SUSQUEHANNA STEAM ELECTRIC STATION  
RESPONSE TO 6/15/95 NOTICE OF DEVIATION  
PLA-4351 FILE NOS. A17-2/R41-2

Docket Nos. 50-387  
and 50-388

# UPS 2D240 POWER SUPPLY SIMPLIFIED DRAWING

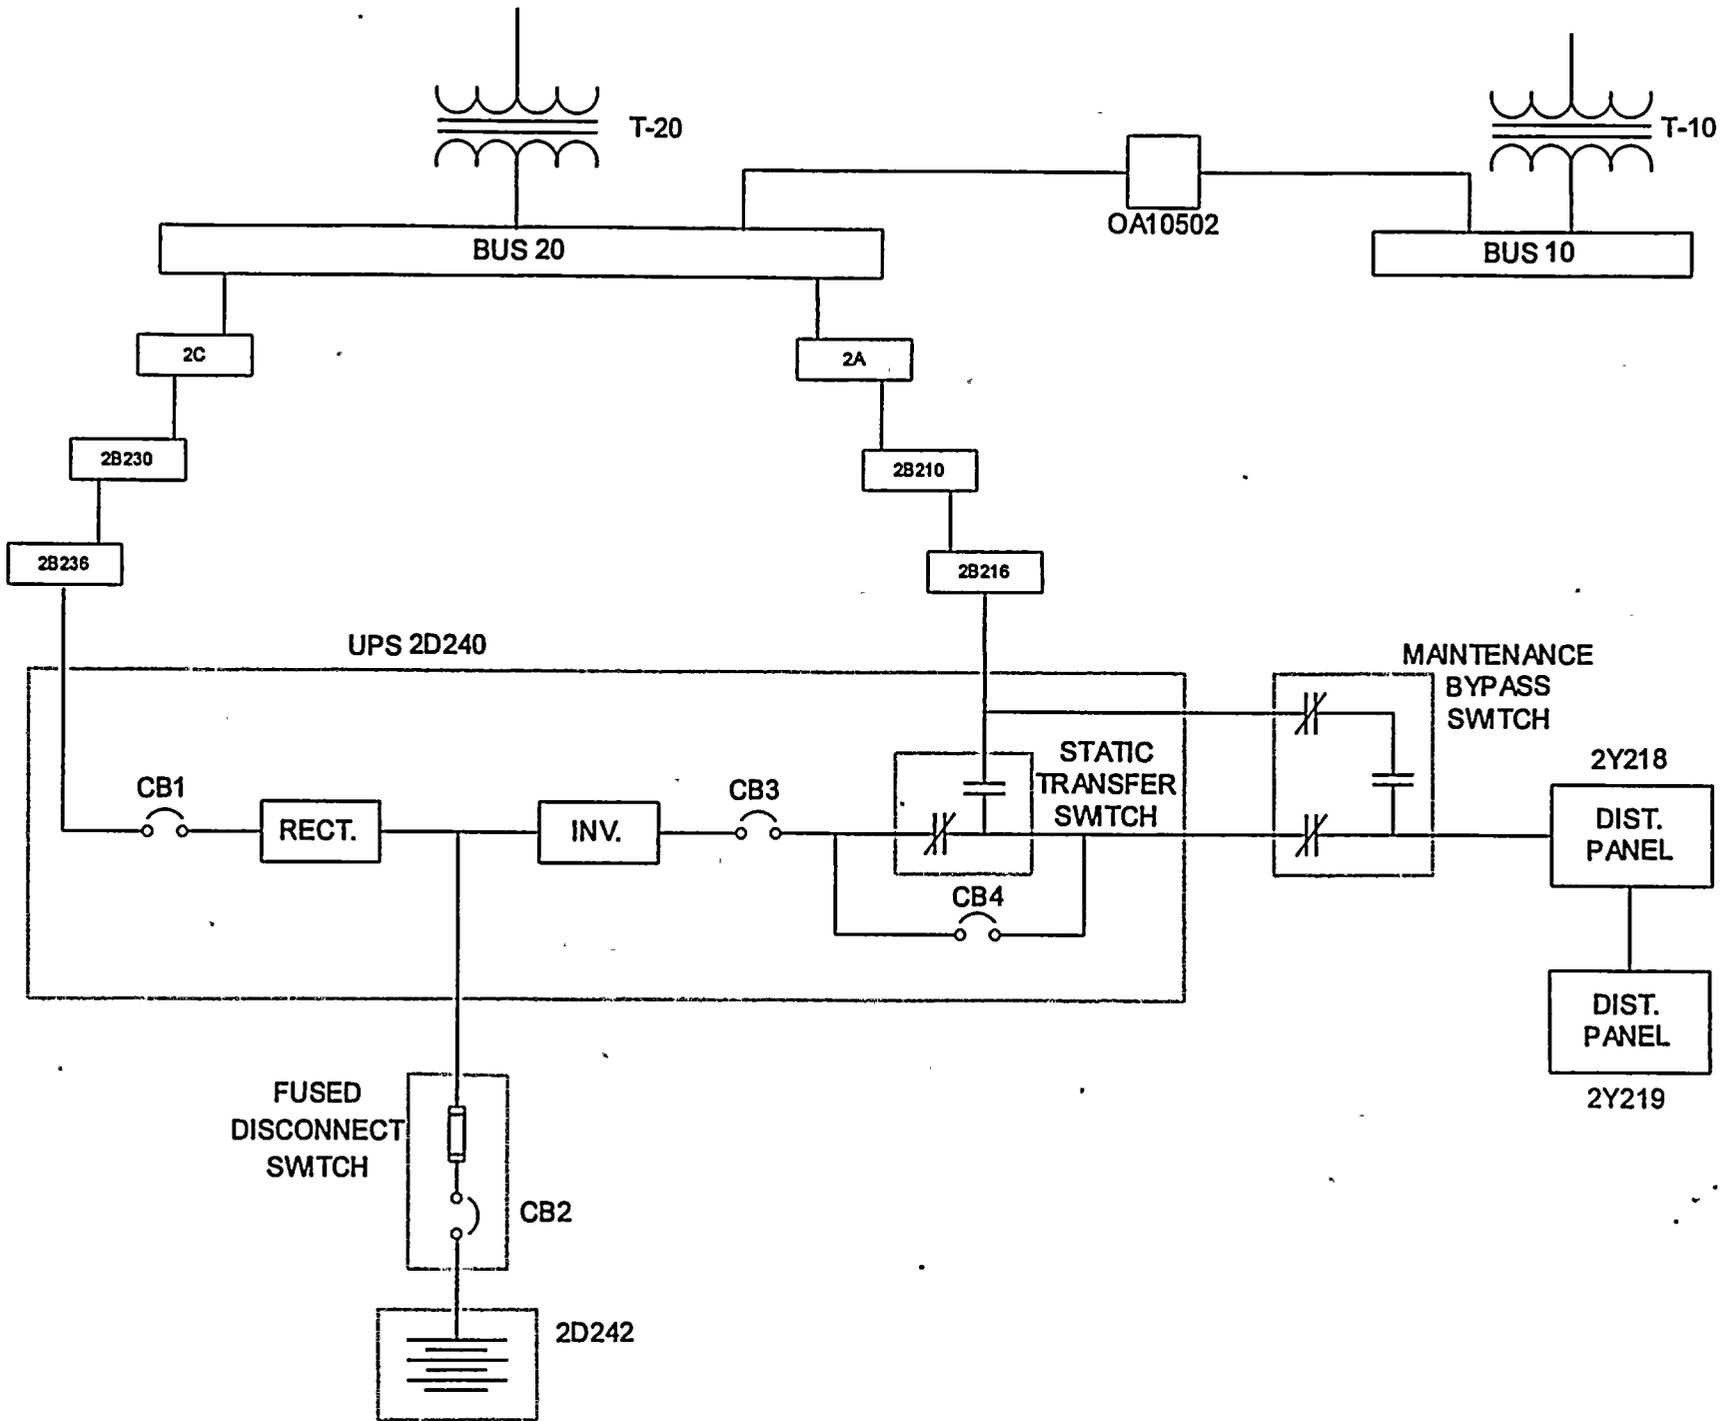
Contrary to the above, after UPS 2D240 failed a post-maintenance test on January 30, 1995, the external maintenance bypass switch was not positioned to bypass the UPS and supply the distribution panel directly from the alternate supply. The UPS was in its normal service

alignment until April 15, 1995, when it failed to provide backup battery power or a transfer (to) its alternate supply in response to an electrical perturbation.”

The event which occurred on April 15, 1995 resulted in a degraded voltage condition on both the primary and alternate supplies. This condition, coupled with the degraded battery, prevented power from being supplied to the non-vital instrument buses. If the external maintenance bypass switch had been placed in its bypass position (i.e., power aligned from the alternate source), power to the instrument buses would have been maintained, since the alternate source was only degraded momentarily, and was never completely lost.

Our subsequent evaluation of the potential impacts on the non-vital loads aligned to the UPS in question has led us to conclude that the optimum alignment when a battery is degraded or the UPS is inoperable is for the switch to be in the bypass position.

- a. Revising the FSAR to clarify the purpose of the maintenance bypass switch, and that its position will be controlled by plant procedures.
- b. Ensuring that this commitment is properly controlled through Operations procedures. This action will also ensure that the basis for any proposed future changes to this commitment are properly documented.
- c. Training of appropriate personnel on the new procedural requirements and their basis.
